January 3, 2003

To: People Interested in the Maiden Wind Farm

Maiden Wind Farm
Benton County, Washington
Final SEPA Environmental Impact Statement
and
Final NEPA Environmental Impact Statement
Submitted Pursuant to Section 42 USC (Sections 4321 et seq.)
and WAC 197-11
by the
U.S. Department of Energy
Bonneville Power Administration
and
Benton County, Washington

Maiden Wind Farm Final Environmental Impact Statement Cover Sheet

**Figure 3.2-1
Land Use, Ownership,
and County Designations
Maiden Wind Farm EIS**

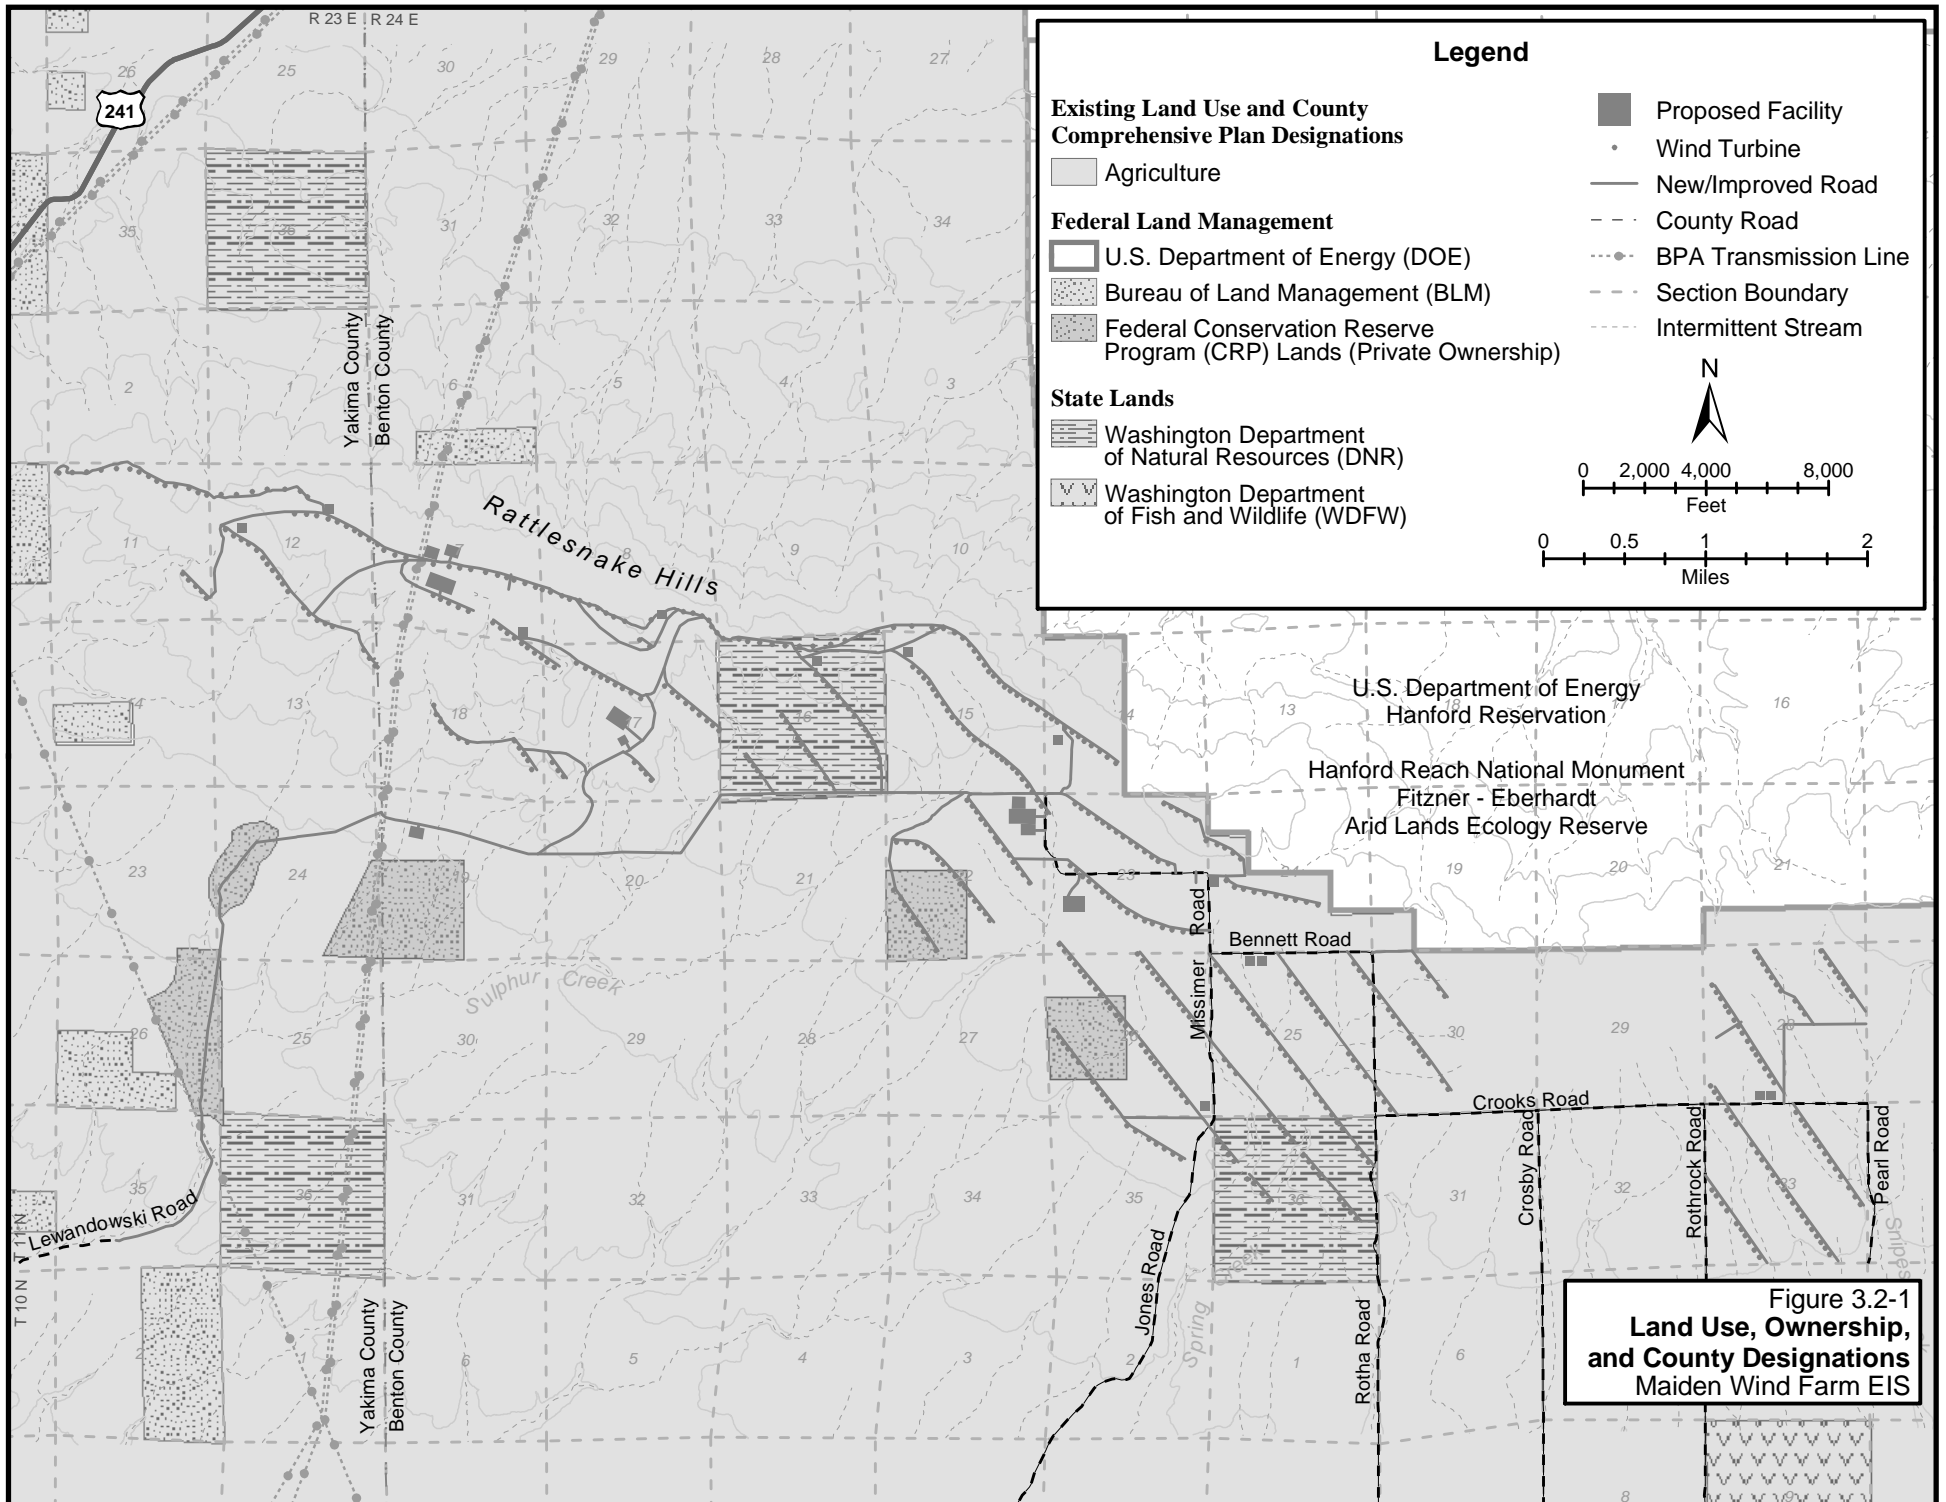
Page 3-4, Figure 3.2-1 is replaced with the figure following this page:

Comment 30: *The DEIS states that the Arid Lands Ecology (ALE) managers don't allow general public access therefore the project would not be affected by the wind project (page 3-8). The United States Fish & Wildlife Service (USFWS) is likely to weigh in on this issue, but we also have some comments because the obvious omission of future management options for ALE reflects other Land Use errors (i.e., WDFW Wildlife areas and DNR land use) referenced within the documents. ALE is a*

No ~~designated or~~ developed recreational facilities exist in the study area. The ALE is not currently open for general public use but is accessible for research studies and field trips through special use permits. ~~Except for two sections of land owned by DNR, the majority of the study area is on private fenced land. The only identified~~ On private land, dispersed outdoor recreational activities ~~is include~~ hunting, ~~which is allowed in some areas only with landowner permission. Other types of dispersed outdoor recreation, such as hiking, horseback riding, camping, wildlife observation, photography, and off-road vehicle use, all of which may occur on private land with landowner permission. These activities also occur on the WDFW Wildlife Area that covers several sections of land approximately one mile southeast of the project site, as well as on the DNR section in the southeastern portion of the project site. Access to the DNR section in the north central portion of the project site is restricted because it is surrounded by private land; however, recreationalists using private lands may also use this DNR parcel.~~

Figure 3.9-1
 Roadway Network and
 Average Daily Traffic
 Maiden Wind Farm EIS

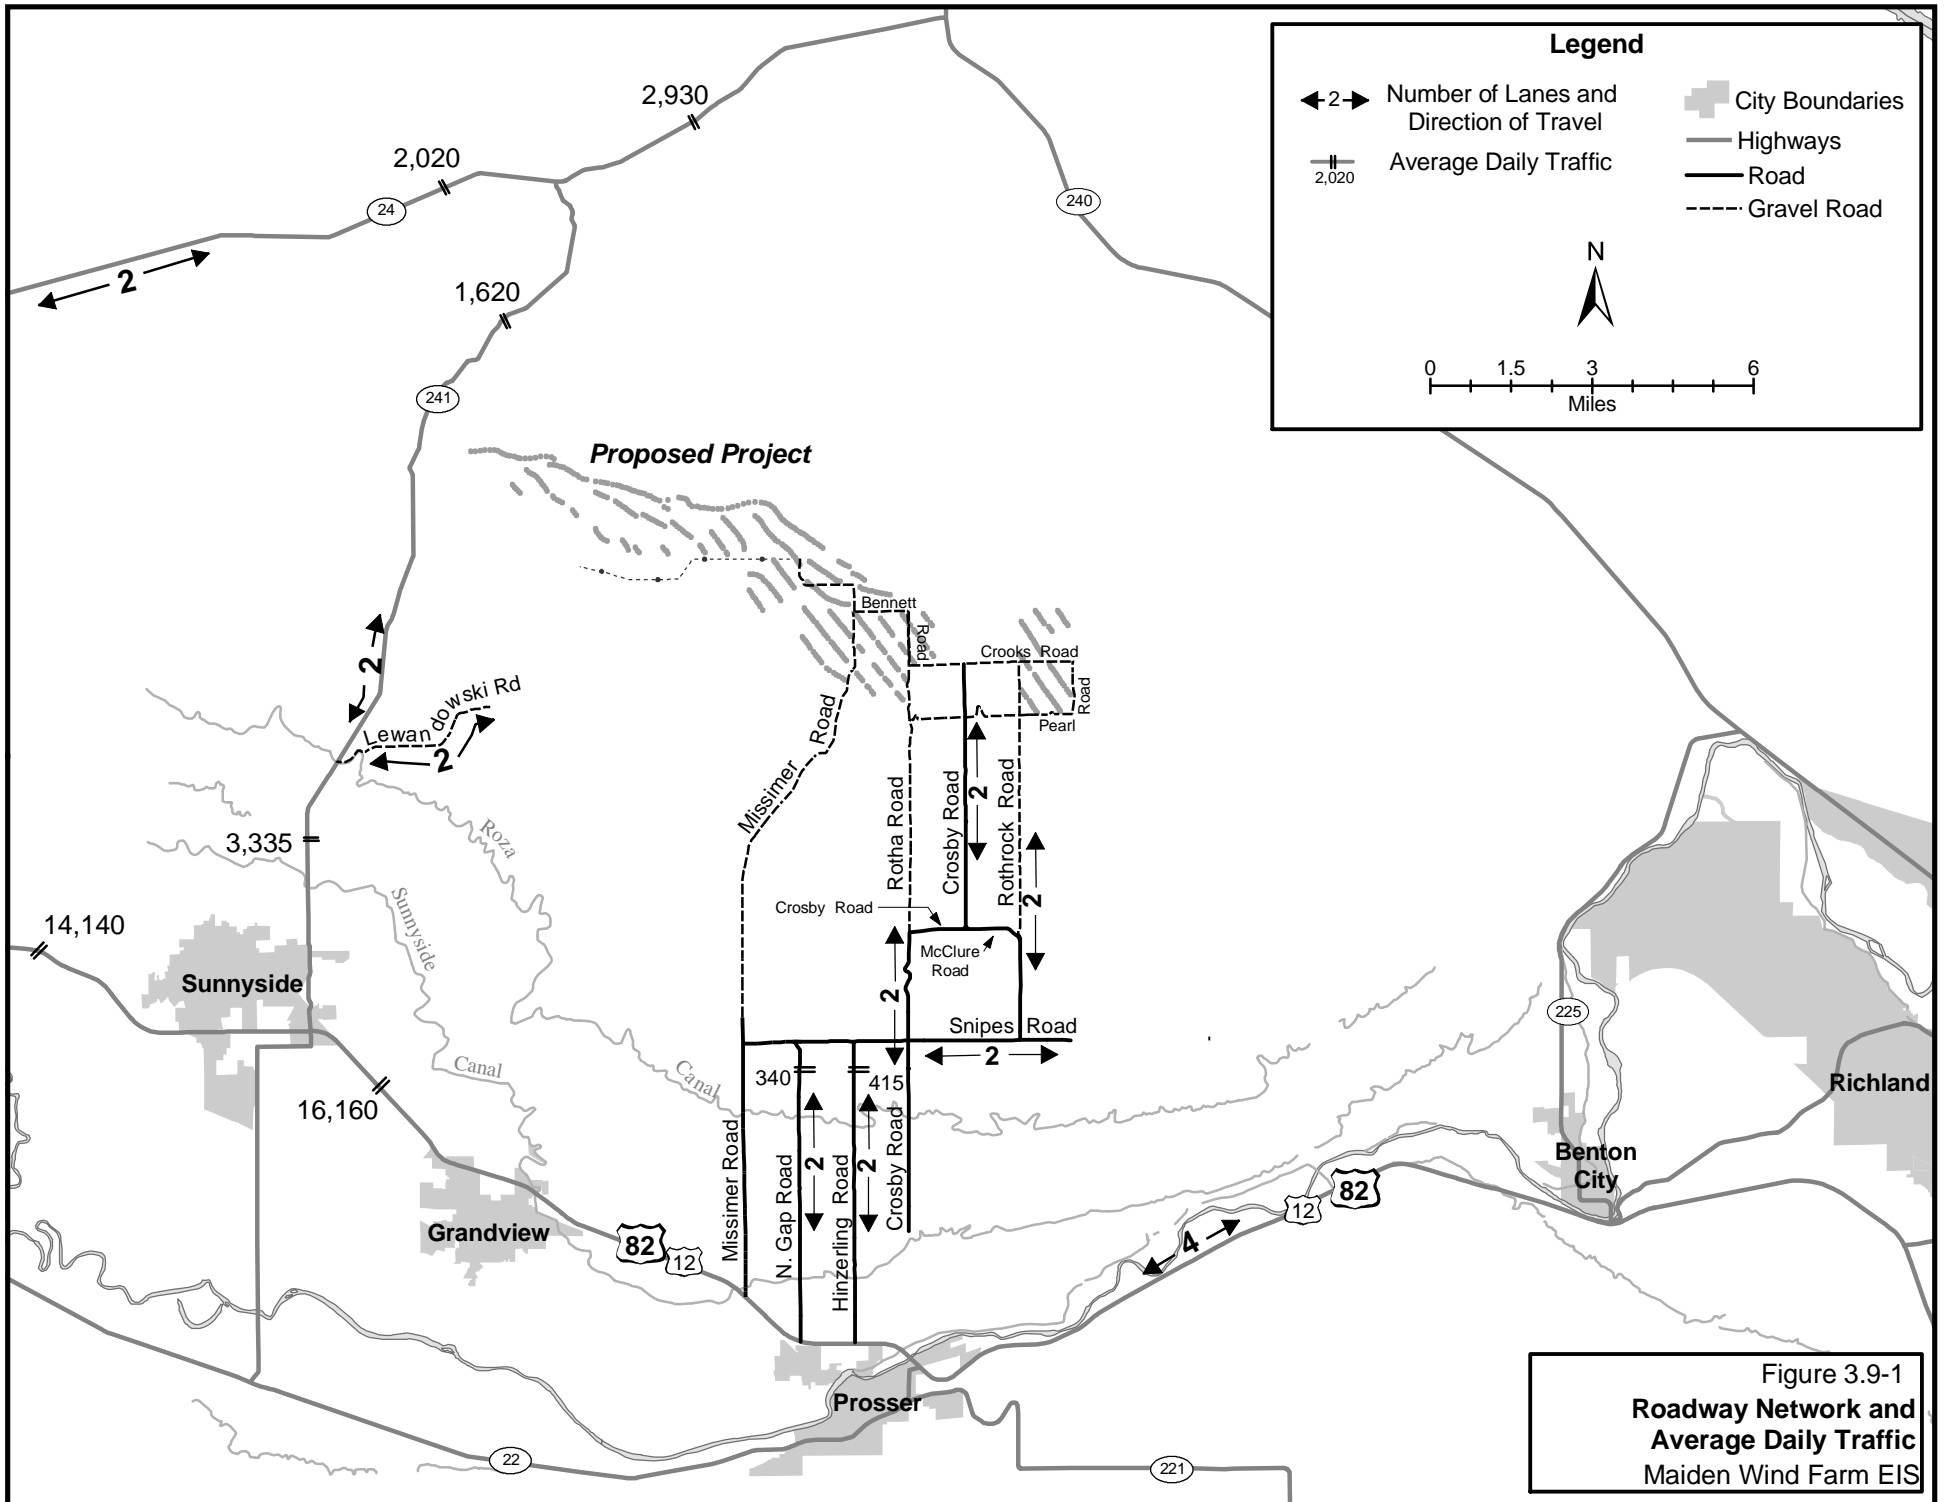
Page 3-102, Figure 3.9-1 is replaced with the figure following this page.

Response: Thank you for the information. EIS Figure 3.9-1 has been corrected to show Lewandowski Road as a gravel road.
